Polarized Drell-Yan Proposal: Questions & Answers

(Fermilab Proposal: P-1027)

(Dated: September 12, 2012)

Figure 2: Siberian Snake B-field strengths.

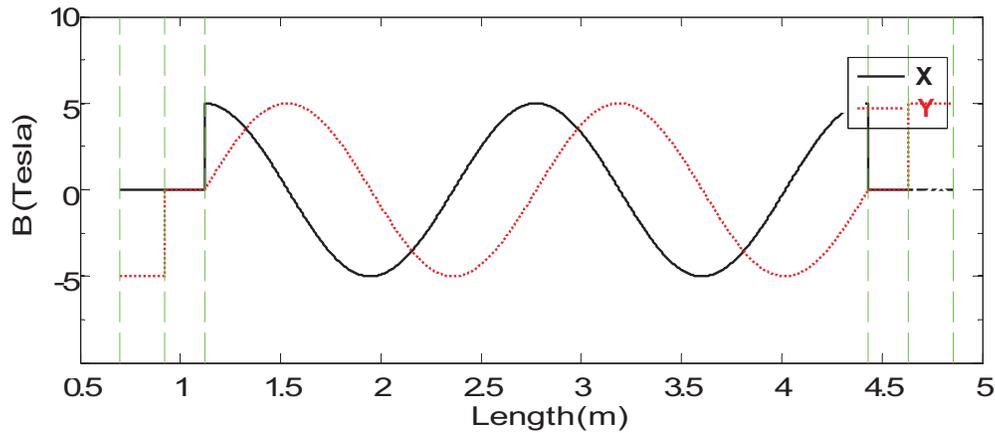
Q 1: *Running with two Siberian Snakes in the Main Injector would impact the core Fermilab program as one of them would require removal of the NOvA extraction kickers. What would the reduction in polarization be with one MI snake and what would be the quantitative effect on the goals of the experiment?*

The consequence of this fortunate finding is that 1 snake is as strong as 2 snakes in the Main Injector, with equally little loss in polarization. Fig. 2 shows a workable solution that consists of a 5-T snake that has a 3.31-m-long double-twist superconducting helical dipole, surrounded by two 0.222-m long 5 T superconducting conventional dipoles each separated by a 0.20-m gap.

A: As described in Section 3, it was fortunate that there was a problem with the 2-snake design. This forced the Siberian Snake experts to find a better solution, which uses less real estate in the accelerator complex, at a substantially lower cost (see **Q 3**), and with no additional loss in polarization. Thus, there is no change to the physics goals of the experiment.
